Working at Heights Assessment

4 Parramatta Square

Walker Corporation

October 2021

1. Upper Rooftop – The roof was provided with a rung ladder, with stiles extending approximately 1,000 mm, for access.

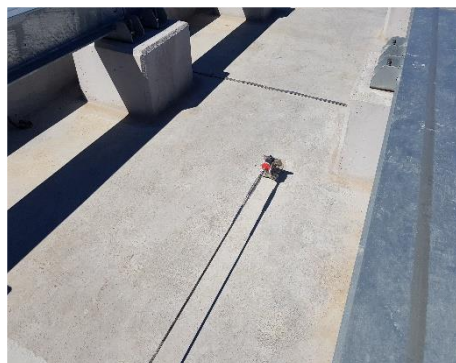
The Upper Rooftop was accessed via a metal rung ladder from the Rooftop area below (**Photo 1**). Various telecommunications equipment was present in this area. A fall from the fixed rung ladder or the landing would result in a fall to the floor of the Rooftop. A metal guard rail with a mid-rail was provided around the entire Upper Rooftop.

2. Rooftop– Static lines observed throughout roof area.

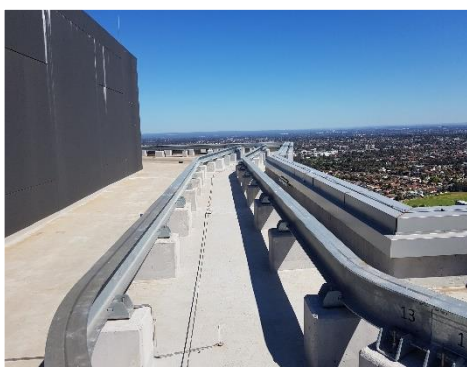
- Anchor points and a static line were provided throughout the rooftop (**Photo 2**). A yearly inspection report, dated 24/05/2021, was sighted;
- A BMU rail was provided, the BMU was accessed from Level 34 and was reported to be used for window cleaning and façade maintenance on a monthly basis. A quarterly BME Inspection report (dated 01/07/2021) was observed; and
- The Rooftop edge was observed to be provided with a parapet wall (**Photos 3**).

4. Level 34, Mechanical Plant Room – A Metal Rung ladder was provided for access to the upper level of the cooling towers. It was observed that the carabiners on the ladder chain were corroded.

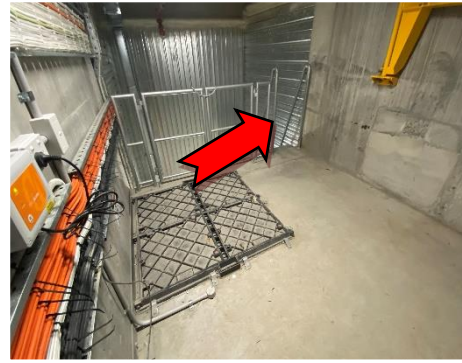
The upper sections of the six (6) cooling towers in the Level 34 Mechanical Plant Room were provided with an elevated platform. The platforms were accessed via fixed steel rung ladders with cages. Chains were provided at the top of the ladders in place of ladder gates. It was noted that a number of the

chains' carabiner clips were corroded and difficult to open (**Photo 4**), presenting a risk of falls when accessing this area.

- Replace/repair the corroded carabiner clips provided to the cooling tower ladder chains;
- Install low headroom warning signage adjacent the rung ladders accessing the potable drinking water tank; and
- Provide highlighting to the pipework located at the base of the potable water tank, right ladder.

Level 34, Working at Heights Control Measures

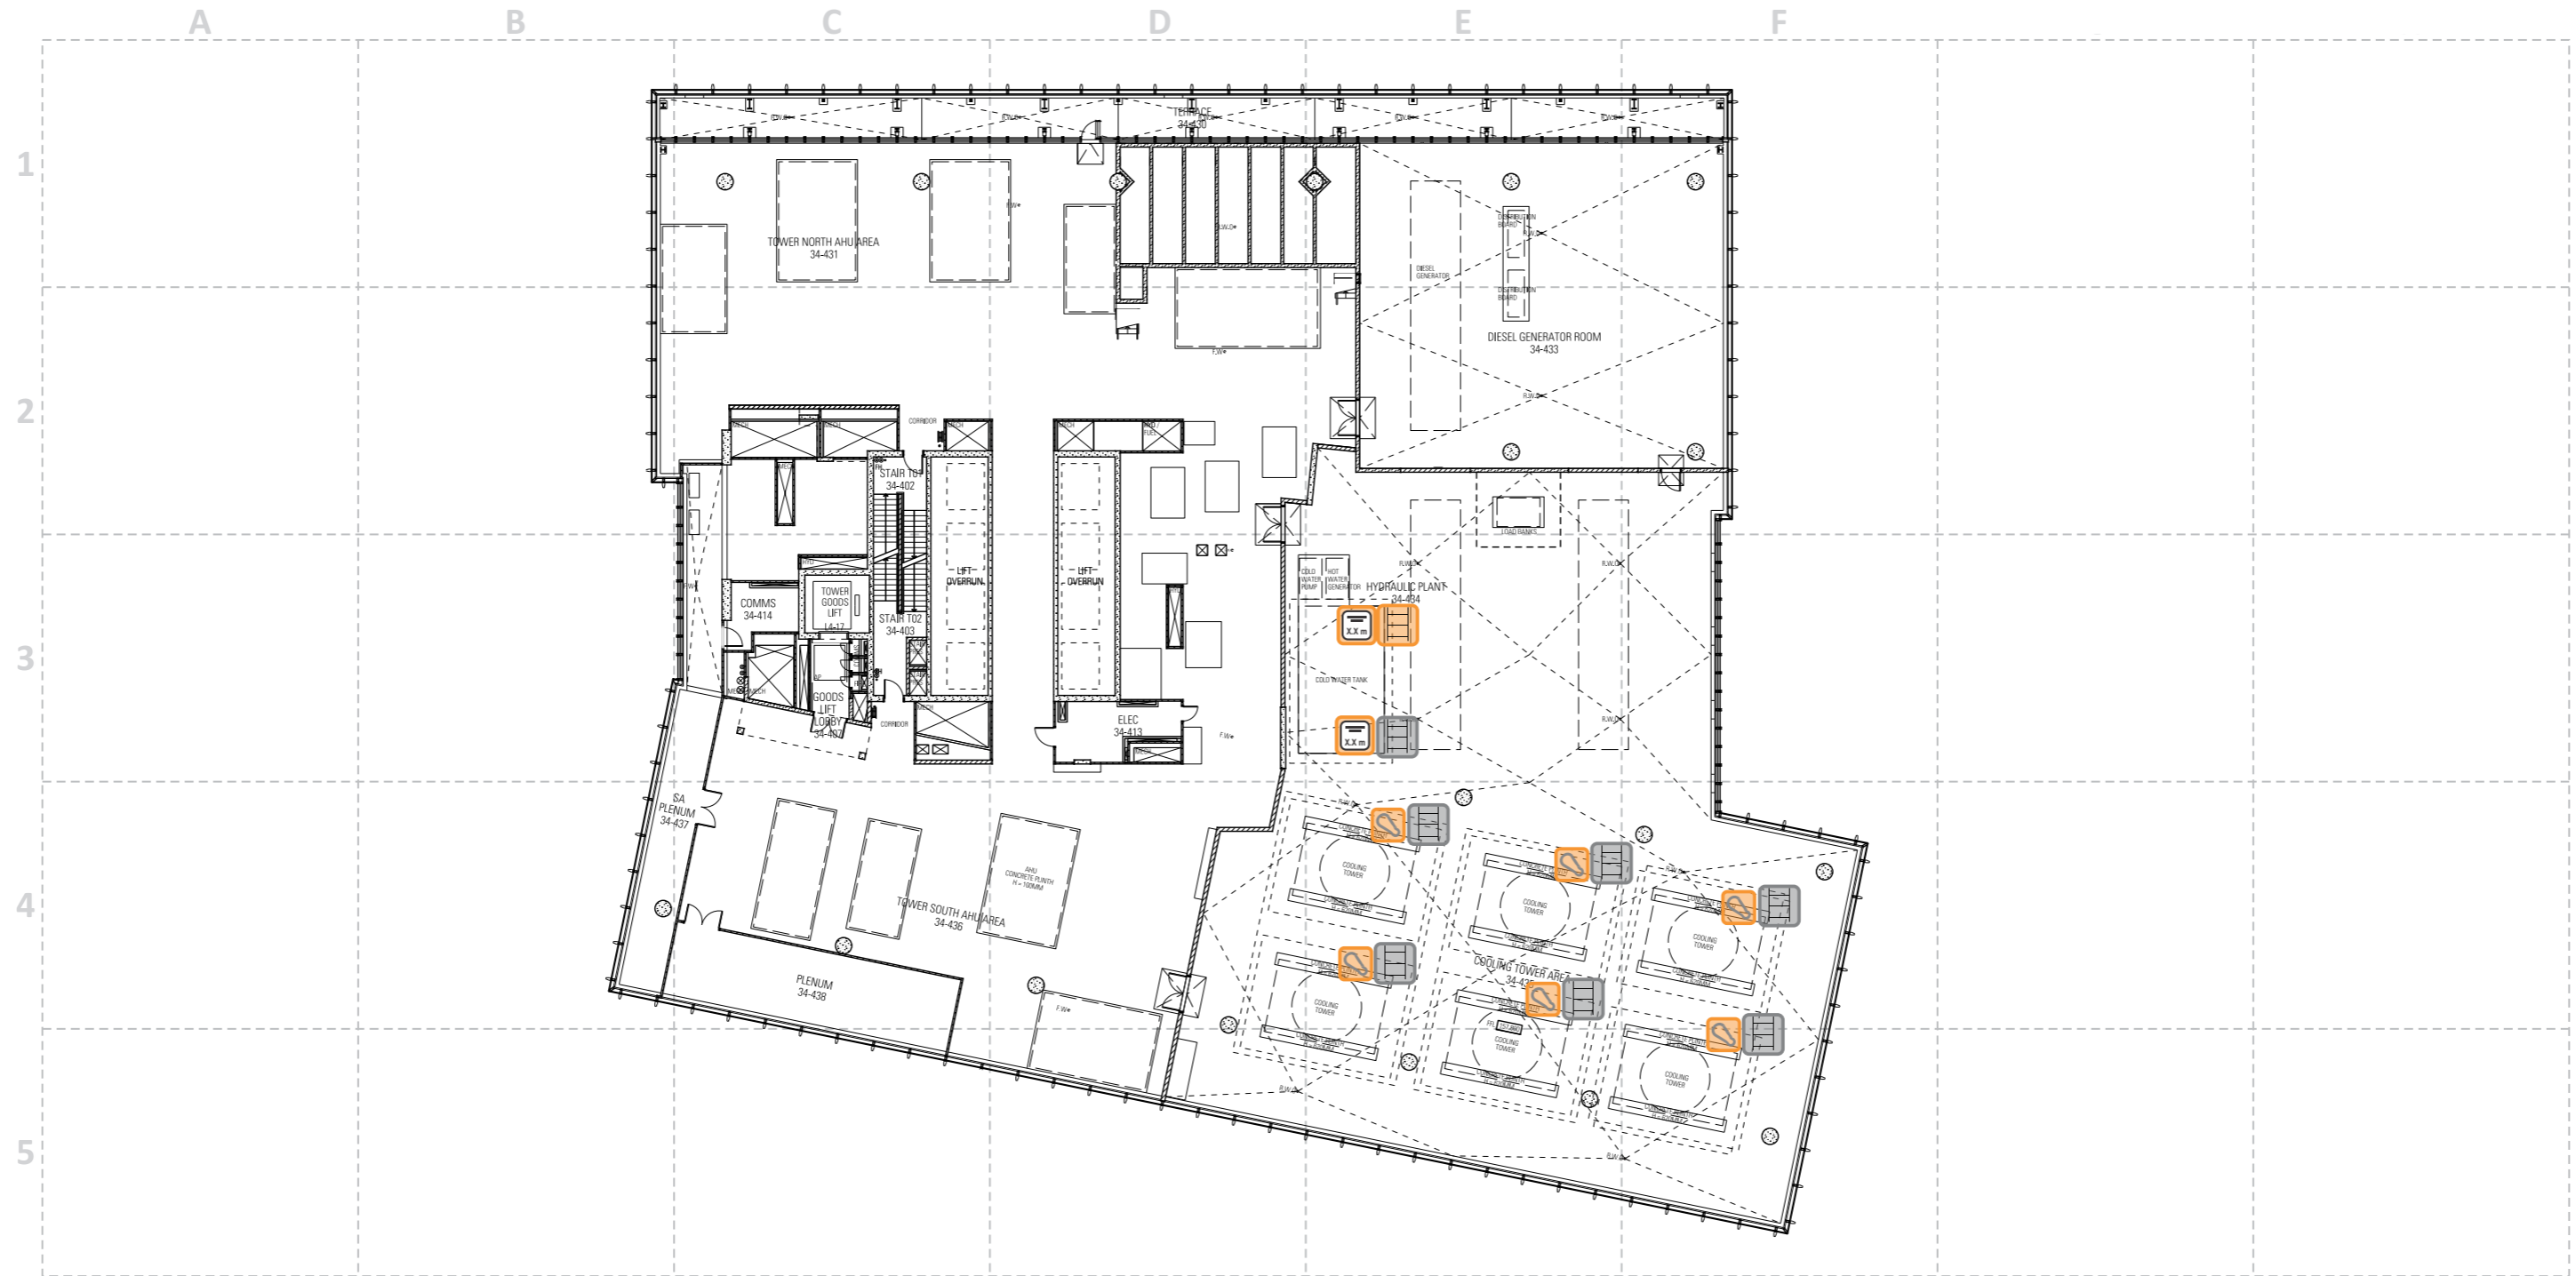
- Reduced head clearance was provided above the water tank and tank access hatch (**Photo 5**); and
- Pipework at the base of the right ladder was noted to be within the 200 mm of clearance from the back edge of the rung, as specified in AS1657, presenting a potential trip hazard when exiting the ladder (**Photo 6**).

Proposed install highlighting to pipework.

Corroded Carabiner.

Low head height. Proposed install warning signage.

Level 1, Working at Heights Control Measures

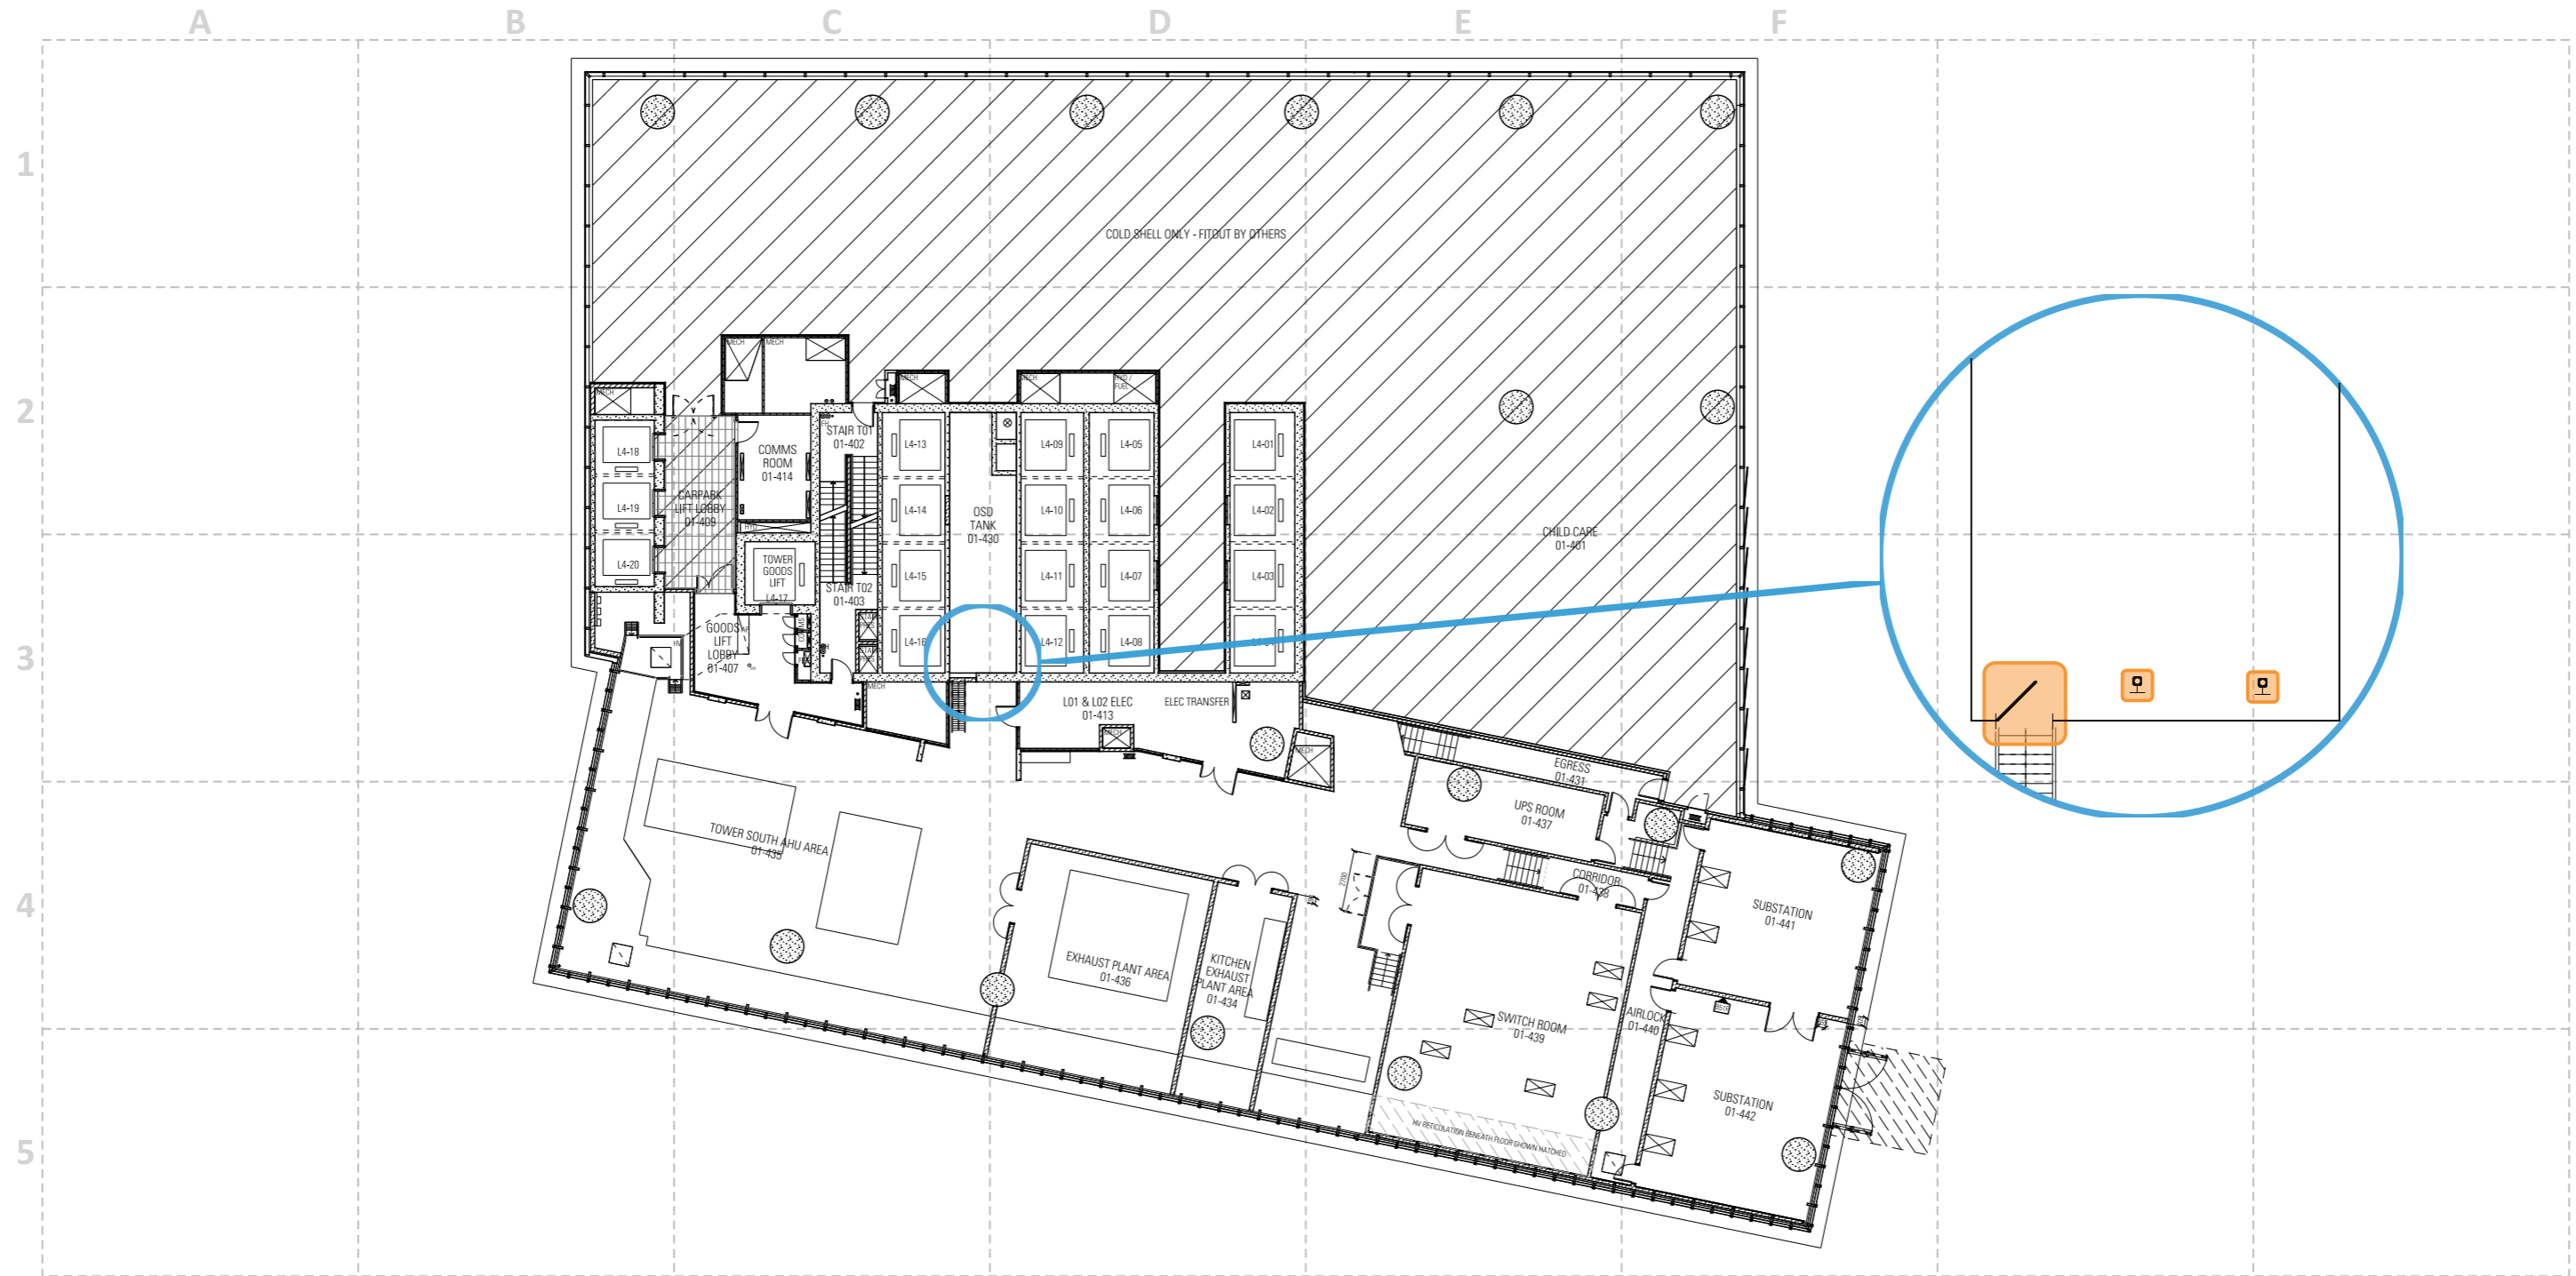
- Inspection tags for the fall arrest points were observed to be out of date (**Photo 7**); and
- Contractors undertaking inspections of fire penetrations were noted to have to stand adjacent the ladder edge (**Photo 8**), however, a ladder gate or closure system had not been installed to reduce the risk of a fall when inspecting the penetrations.

- Legend:
- Existing Anchor Point with out of date tag.
 - Proposed Installation of a Ladder Gate

- Engage a competent person to inspect and maintain anchor points on an annual basis; and
- Install a ladder gate to the top of the step ladder to reduce the risk of falls.

Level P3, Working at Heights Control Measures

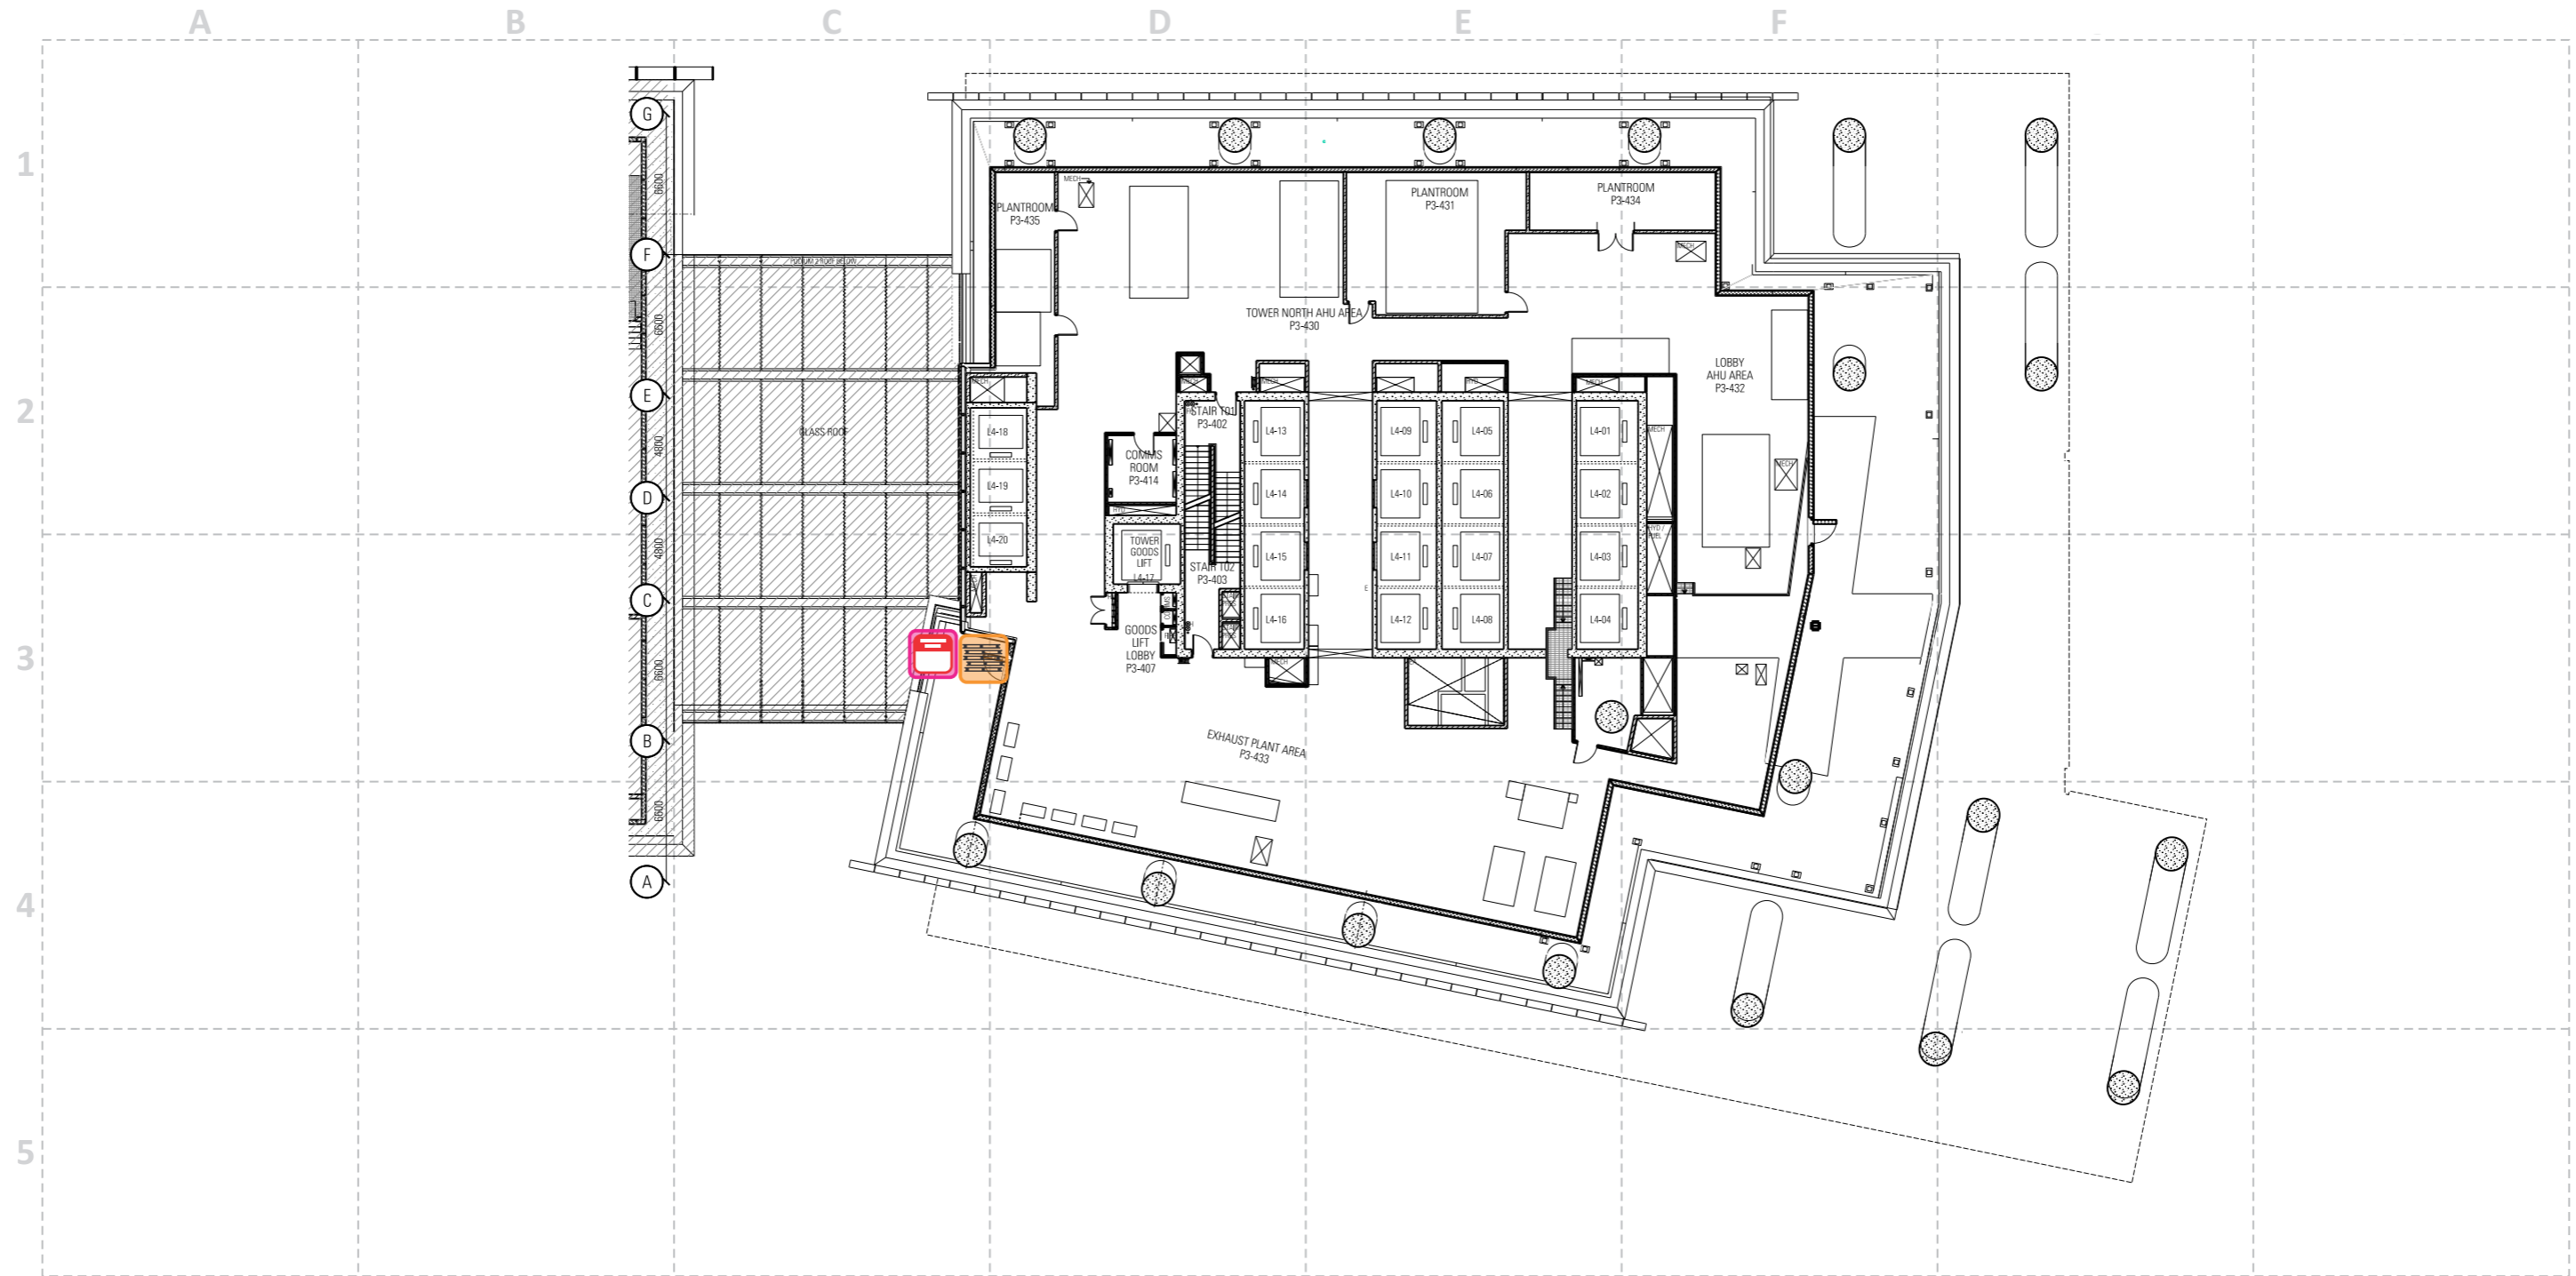
- No indication of the load bearing capacity for the trafficable glass roof was observed (**Photo 9**); and
- Building materials were stored in front of the door, obstructing access (**Photo 9**).

Stored Building Materials near walkway.

Proposed location for Safe Weight Limit signage.

Install a sign displaying the Safe Weight Limit (SWL) of the glass.

Remove building materials obstructing the entryway.
